HIGH STRENGTH STEEL ANCHOR ROD PROBLEMS ON THE NEW BAY BRIDGE

Revision 1

November 12, 2013

**COMMITTEE ON TRANSPORTATION AND HOUSING
CALIFORNIA STATE SENATE**

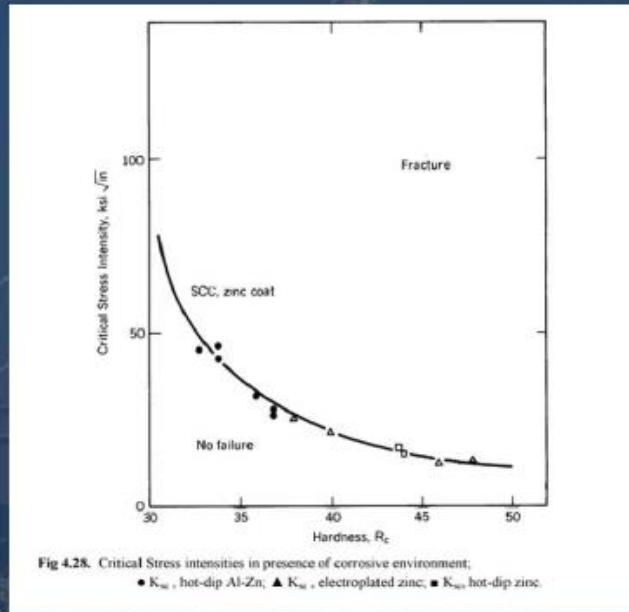
Figure 17 is one of the slides that the TBPOC Chairman presented at the May 8, 2013 BATA Briefing.⁷¹ The graph he presented was supposed to mean that the critical stress intensity factor for stress corrosion cracking, K_{Isc} , along the ordinate (the vertical axis), decreases with hardness along the abscissa (the horizontal axis). TBPOC engineers mislabeled the graph in Figure 17 as “Sample Critical Stress Curve from ...,” indicating lack of expertise in fracture mechanics related terminology. The critical stress

The graph in Figure 17 has open triangles and open squares along the lower-right part of the curve. These are denoted by solid triangles and solid squares in the notation below the graph. This error (inconsistency) occurred when Fisher and his co-authors “borrowed” the graph from the Townsend’s original paper and the TBPOC blindly copied the graph with errors in it from the book by Kulak et al.⁷³ Then, the TBPOC Chairman said, referring to this graph in Figure 17, that the larger the rod diameter, the lower the stress intensity factor for SCC. This graph has no data on the rod size; he would have needed another graph to make his point about the effects of rod sizes.

Problems arise when the Townsend Test is misrepresented as a test to determine “long-term stress corrosion susceptibility” as in Figures 17 and 18. The $K_{I_{SCC}}$ test has no ability to predict a “longer-term” performance of a rod in a given environment such as the San Francisco-Oakland Bay. Therefore, the caption of the graph in Figure 17 or the definition given by the TBPOC, shown below, is incorrect.⁷⁶

Figure 22 (a) Part of hardness data for 3½ inch PWS anchor rods. (b) and (c) Hardness traverse plots for Rod E-075 and E-084 in the table in (a).

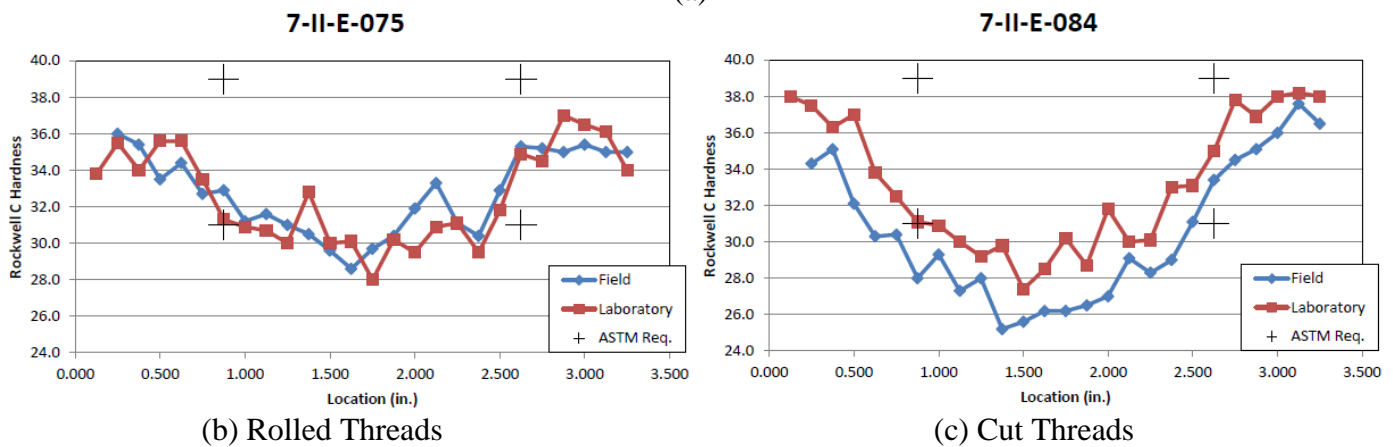
Figures 22 and 23 present part of a massive amount of data generated for Item #7, 3½ inch PWS anchor rods in File E17. None was useful in determining the effects of cold rolled threads, including the data presented in Figure 23a. It was apparently intended to show no differences were found between the rods with cut threads and those with rolled threads. However, what is missing is the recognition that neither the lab Rockwell hardness tests nor the field portable hardness tests are useful in determining the effects of the cold thread rolling on hardness unless the test method was specifically directed toward that purpose. This could be best accomplished by microhardness tests, either in the HK or the HV scale.

Figure 22 presents an example of these hardness test data and corresponding hardness traverse graphs for two cases of Item 7, 3½ inch PWS anchor rods. The shortcomings of these data, specific to the anchor rods with rolled threads, were already discussed.

Figure 23 Hardness traverse data for Item #7, 3½ inch PWS anchor rods, from File E17.

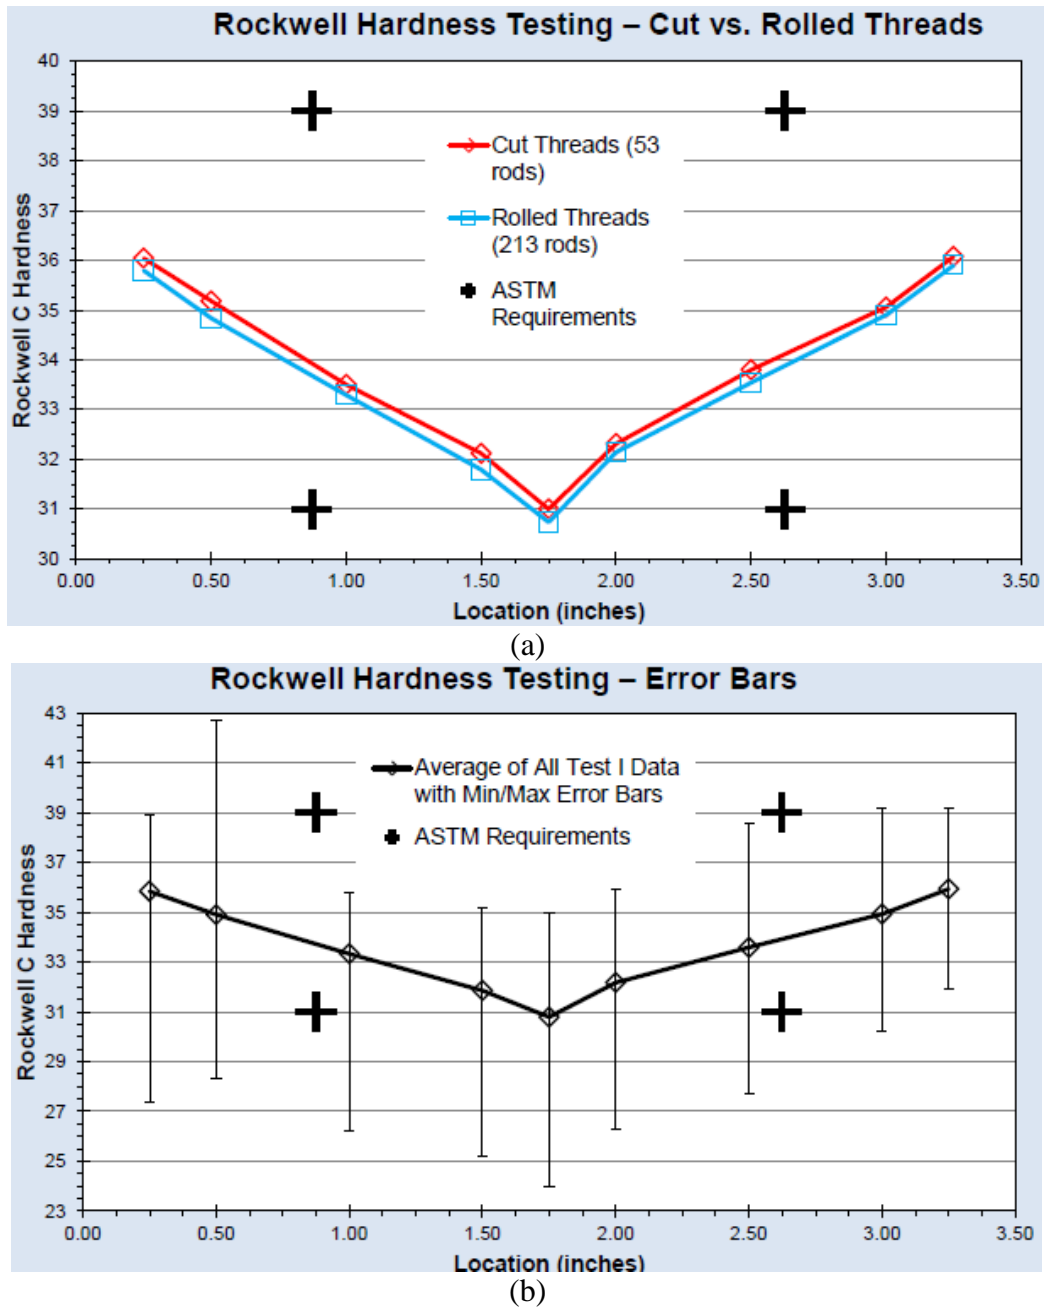
For Item #7, PWS (Parallel Wire Strands, main anchor cable), the last row in the above table, 36 HRC was used for hardness. This was apparently based on the “Average of All Test Data” shown in Figure 23b. It shows that the surface hardness at 0.25 inch from the surface ranged between 27 – 39 HRC. Even these hardness data are useless for the anchor rods with rolled threads. As discussed before, the hardness of the surface layer of the root of cold rolled threads would be much higher than that indicated by Figure 23b. The Greg Assessment Tool does not take the effect of cold work in the surface layer into consideration. Thus, it is not applicable to the anchor rods with rolled threads or any other rods that do not fit the data used.

The title of (b), “Error Bars,” is mislabeled for “Range Bars.” The spread in the hardness data should not be labeled as a testing error.

Figure 25 Sketch showing the locations of potable hardness test indentations and examples of hardness traverse data that would look flat if plotted.¹⁰⁹

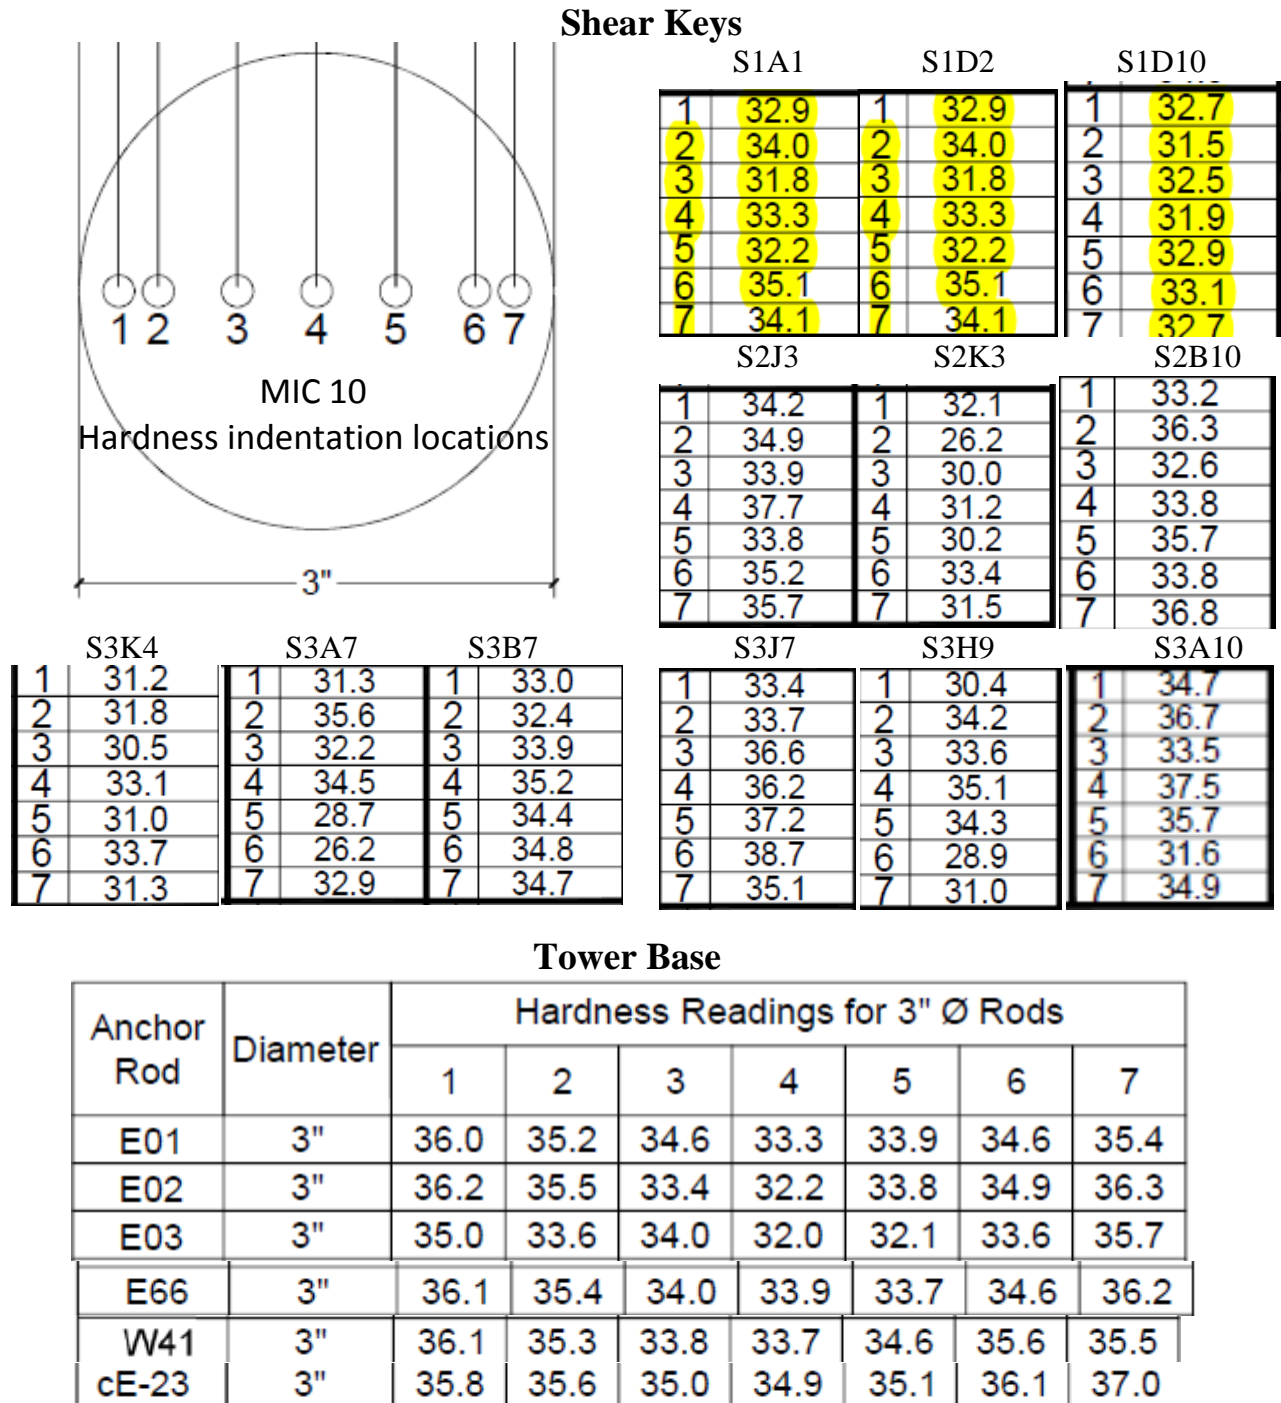
Conversely, many hardness traverse data in File E17 would be flat across the diameter, if plotted, because of little differences between the hardness near the circumferential surface and the core. Examples are shown in Figure 25. These flat hardness data would represent the “end quench effect.” It would be possible that the cross sections with flat hardness data were the ends of the rods when they were hardened and tempered. This is the very reason why ASTM F606 (3.1.3) requires an arbitration hardness test on a cross section approximately one diameter from the thread end to void the end quench effect.

Many hardness data would look flat rather than bowl shaped if plotted as mentioned already. Some examples of flat hardness traverse data are shown in Figure 25.

Figure 26 Examples of hardness traverse curves that are M shaped. The hardness for surface layer is lower than that at 1/2 inch from the surface. This is an anomaly for 4140 steel rounds that were quenched and tempered properly.

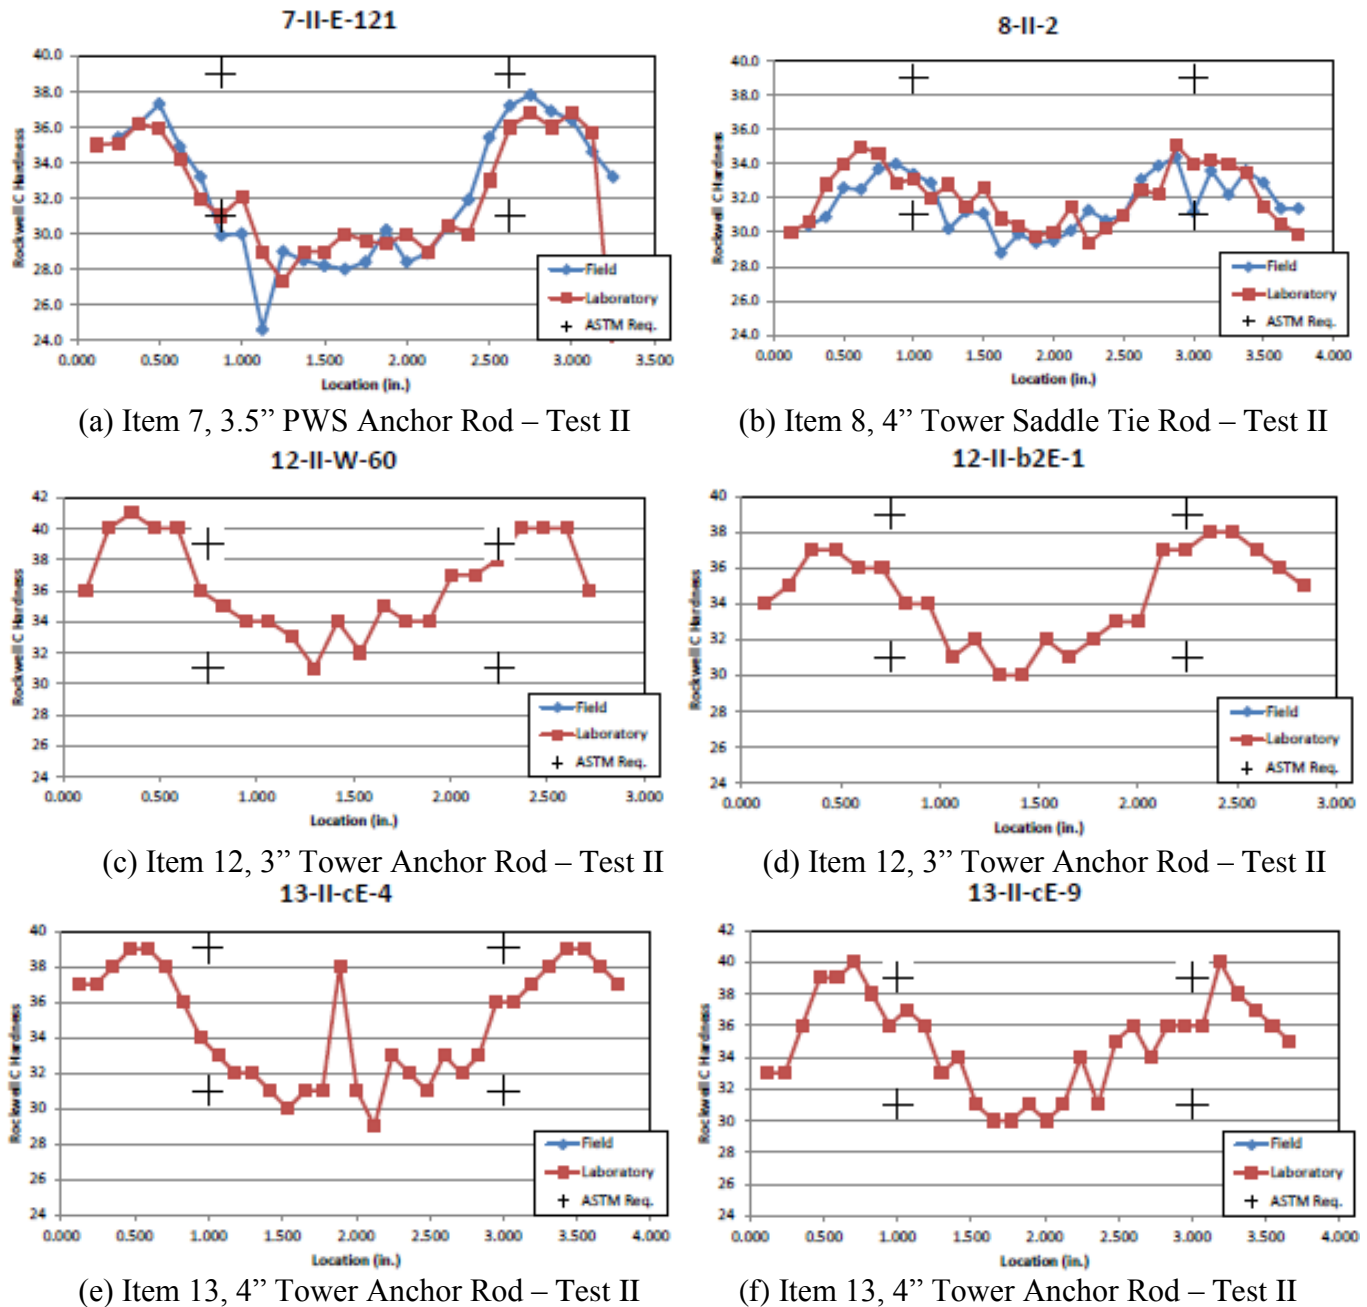
Also, many of the hardness traverse curves in File E17 were M-shaped. Several examples are presented in Figure 26. These hardness data are atypical of 4140 steel rounds, quenched and tempered. Caltrans should have provided some explanation as to the M-shaped hardness traverse data and their effects on the susceptibility to HE. If no acceptable metallurgical explanations are readily available, Caltrans should have done a metallurgical evaluation to determine why the hardness traverse data are M-shaped and what their effects may be with regards to their integrity against EHE failures.

Caltrans needs to conduct a metallurgical evaluation to determine the reasons why the hardness traverse are M-shaped, rather than bowl shaped, and the effects of M-shaped hardness distribution on environmental hydrogen embrittlement (EHE) or long term stress corrosion cracking as defined by the TBPOC.
